DEVELOPMENT DETERMINATION PANEL MEETING

WEDNESDAY 13 DECEMBER 2023

3.1	DA2023/1448 - 38 Bower Street MANLY - Alterations and additions to a dwelling house and associated works	4
3.2	DA2023/0898 - 22 Bligh Crescent SEAFORTH - Demolition works and construction of a dwelling house including swimming pool.....	69

Figure 1. Floor space calculation diagram.

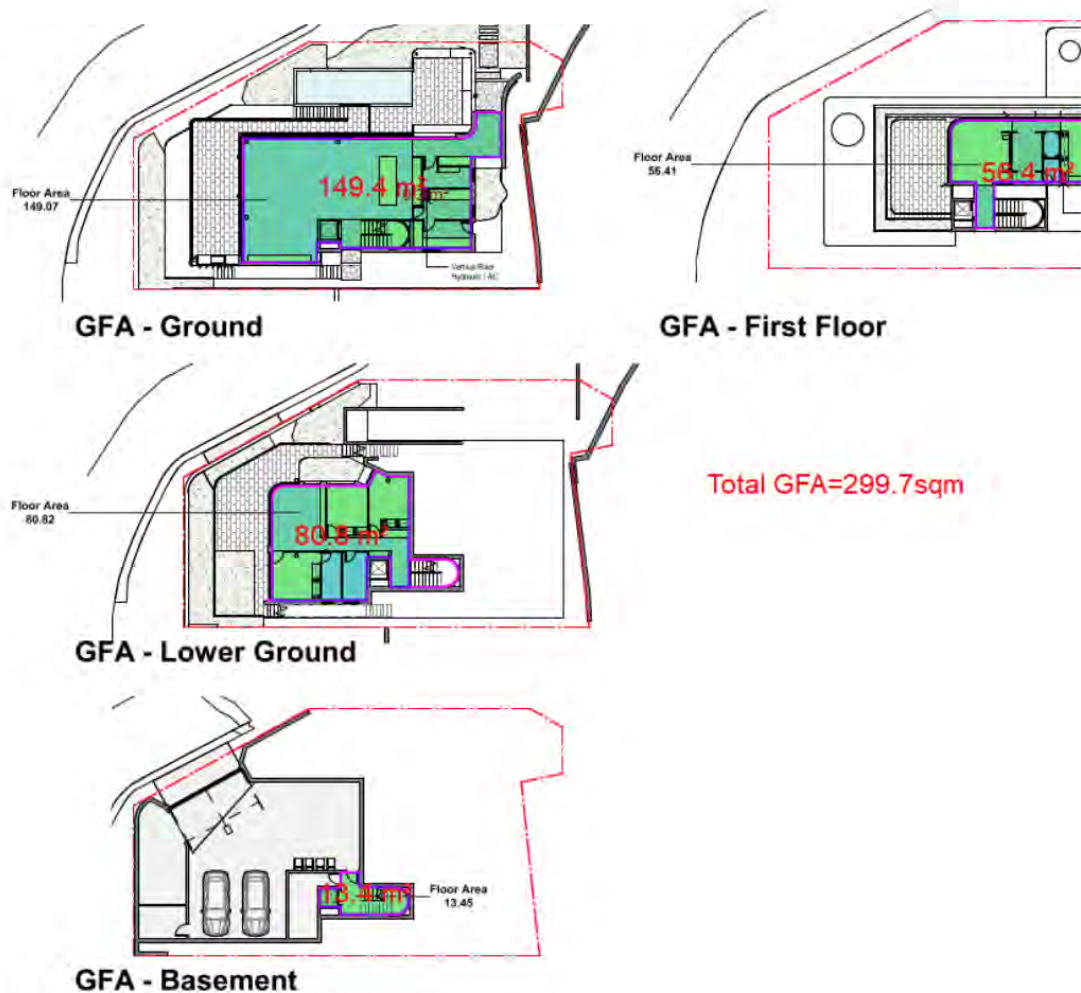
Development standard:	Floor space ratio
Requirement:	0.4:1 (199.96m ²)
Proposed:	0.6:1 (299.7m ²)
Percentage variation to requirement:	49.9%

Figure 7. Number of storeys diagram.

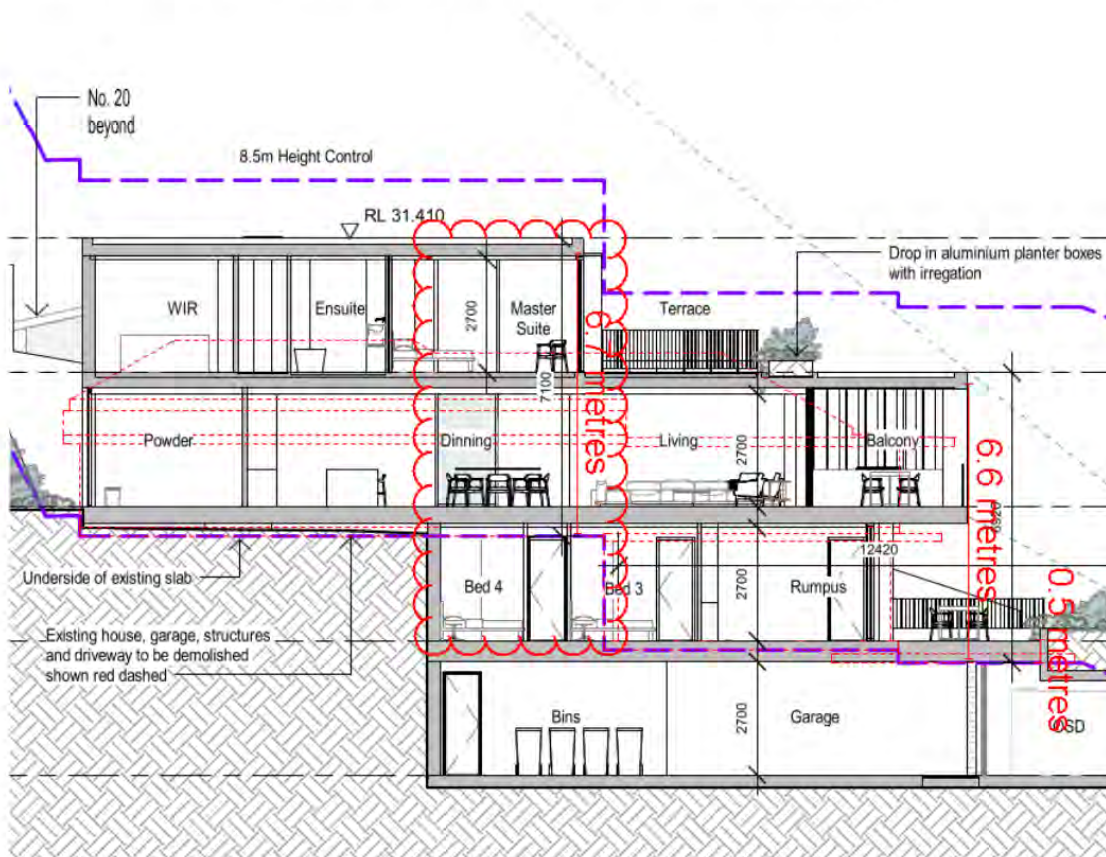
The proposal partly exceeds up to three (3) storeys as displayed in the below diagram.

Image: Height of the dwelling house roof apex is being reshaped. Minor amendment were made to eliminate balustrade and terrace area (red) projecting above the EGL height line. Existing subfloor

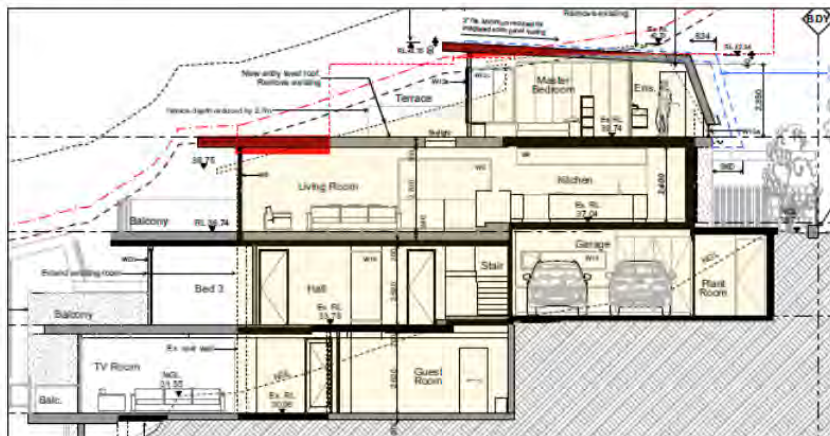
Development standard:	Building Height
Requirement:	8.5m
Proposed:	8.97m
Percentage variation to requirement:	5% (0.47m)

Figure 1. Proposed maximum building height encroachment. Extent of breach indicated in red shading.

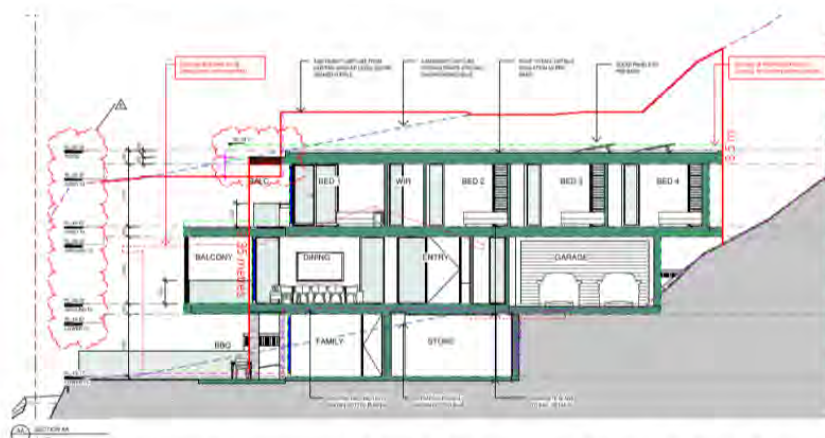
Development standard:	Clause 4.3 Height of Buildings
Requirement:	8.5m
Proposed:	9.35m
Percentage variation to requirement:	10%

Figure 2. Lower ground floor level gross floor area indicated in green hatching.

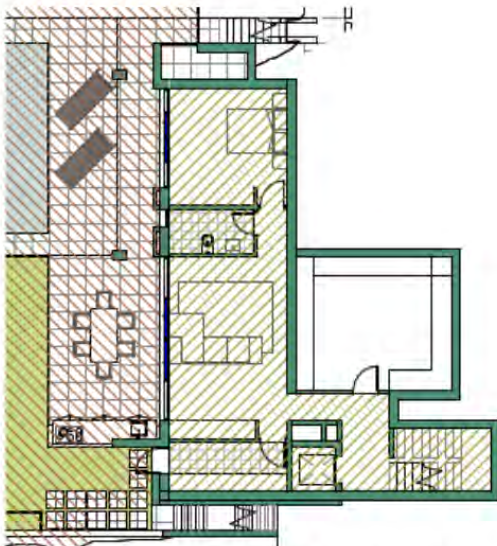
Development standard:	Clause 4.4 Floor Space Ratio
Requirement:	0.4:1 (271.0m ²)
Proposed:	0.44:1 (299.6m ²)
Percentage variation to requirement:	10%

Figure 5. Elevational shadow diagrams between 9am and pm, additional overshadowing indicated by red shading (prepared by Ursino Architects, Rev B, dated 31 October 2023).

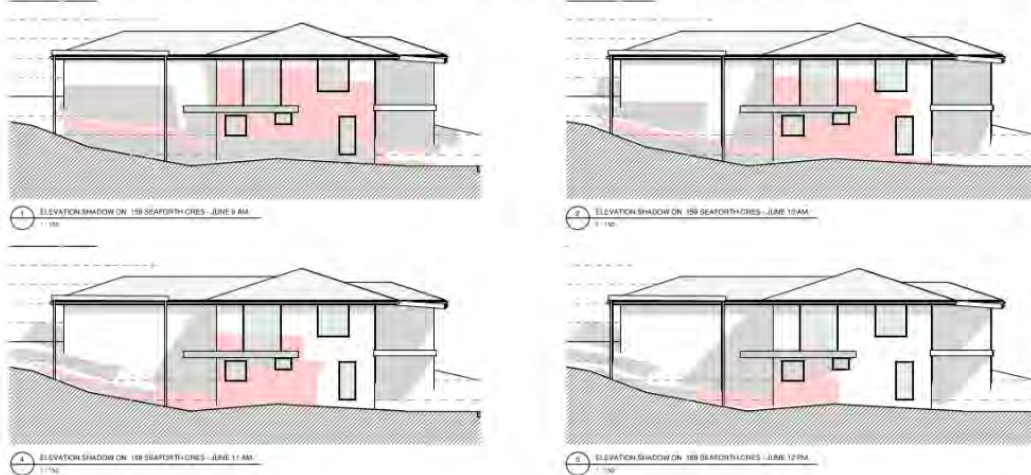
indicated in the figure below). It is noted that the north-western elevation of 159 Seaforth Crescent has sliding glass doors and fixed windows which provides solar access (unobstructed by the proposed development) to the internal living room, dining area and kitchen on the first floor.

Figure 6. Elevational shadow diagrams between 12pm - 3pm, additional overshadowing indicated by red shading (prepared by Ursino Architects, Rev B, dated 31 October 2023).

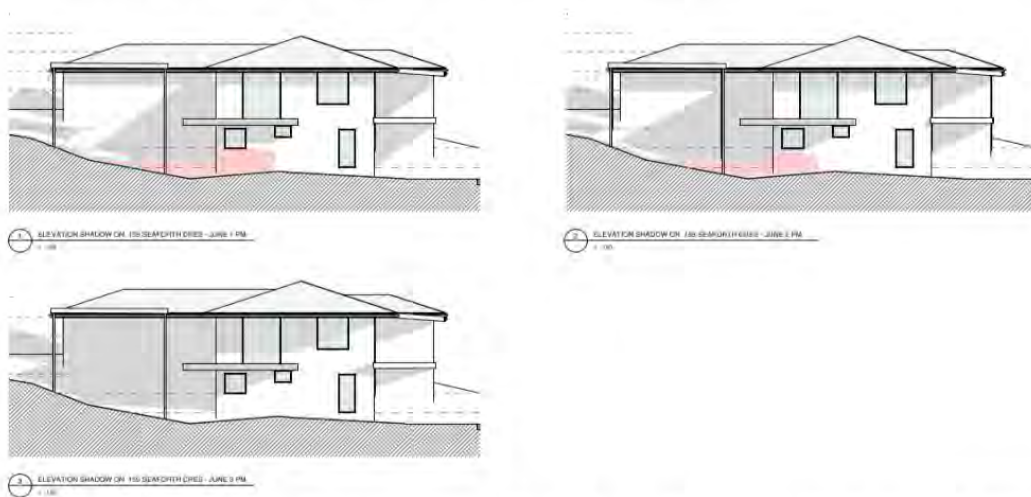
Between 12pm and 3pm, the proposed development does not cause overshadowing to the internal living rooms of 159 Seaforth Crescent (as indicated in the figure below).

Figure 1 - Extent of height breach - secondary dwelling

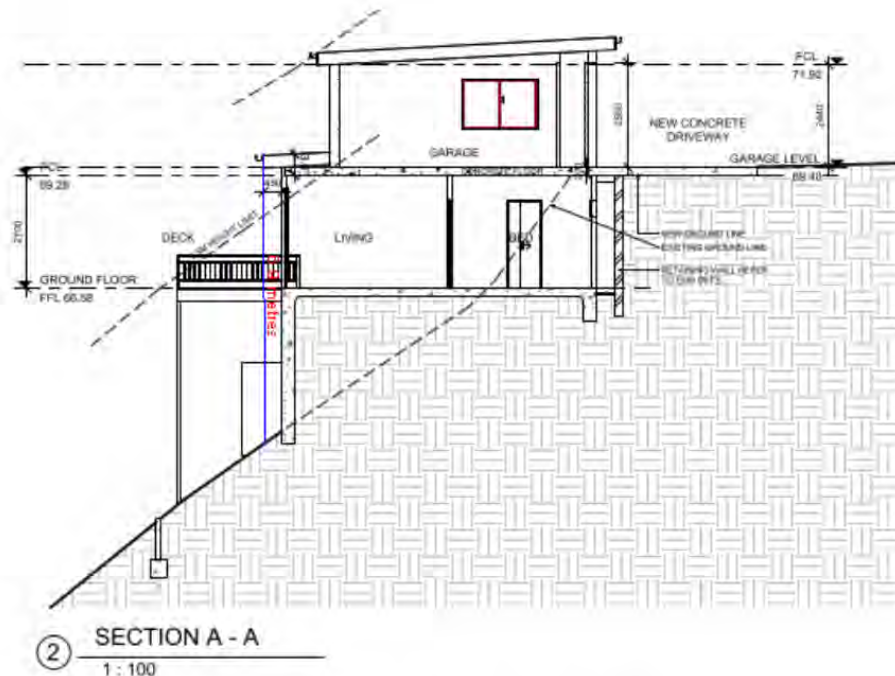
Development standard:	Height of buildings
Requirement:	5.5m
Proposed:	6.9m
Percentage variation to requirement:	25.5%

Figure 2 - Demonstrating 1.1m non compliant side setback for the stairs and landings

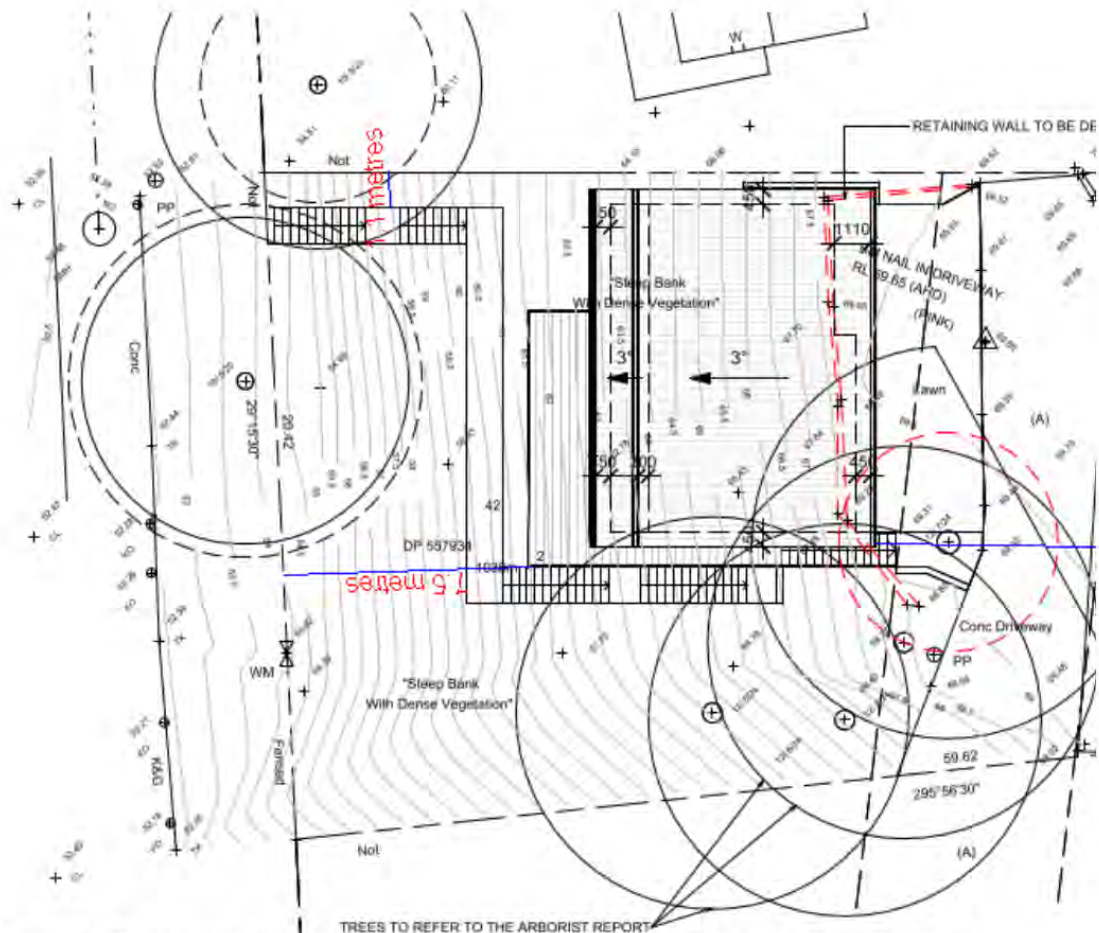
The location of this staircase results in non-compliance with the control as it is not set back 2 metres from the side boundary (proposed stairs/landings 1.1 metres setback).

Figure 3. Section from the north elevation displaying the building envelope non-compliance

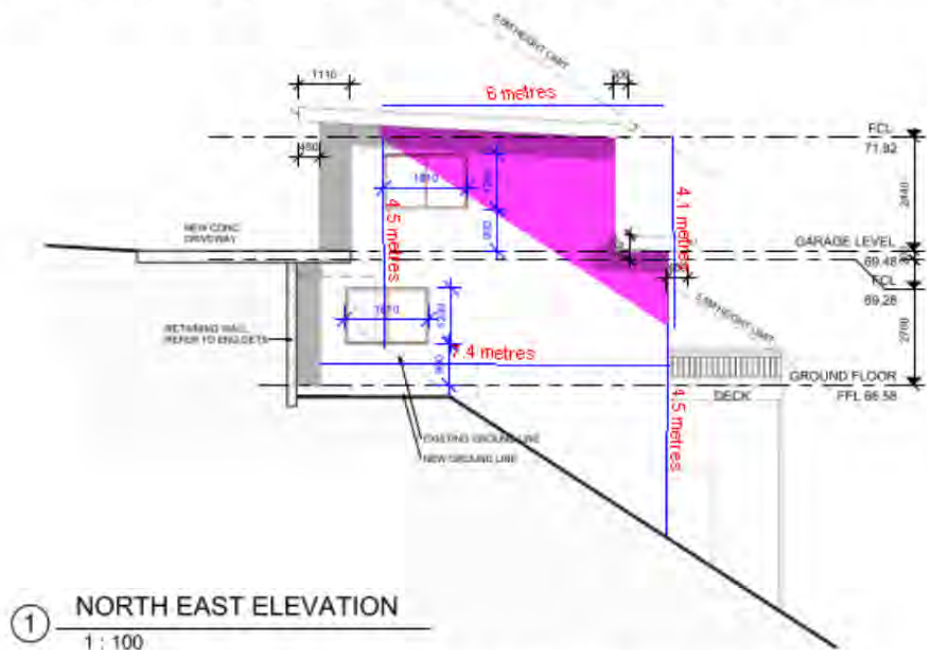
A building envelope of 45° measured at a height of 3.5 metres applies to the site in accordance with Part D1.11 of P21 DCP. There is a proposed envelope non-compliance on the northern side of the property, as displayed in Figures 3 & 4 below. As Figure 3 shows, the non-compliance is 6 metres in length, comprising of a height of 4.1 metres (111.7%) above 4.5 metres building envelope (3.5 metres building envelope + 1 metres side setback). A condition is recommended that increases the northern side setback to the garage floor level from 1 metres to 2.2 metres which will reduce the non-compliance considerably down to 2.1 metres (60%) as shown within Figure 4.
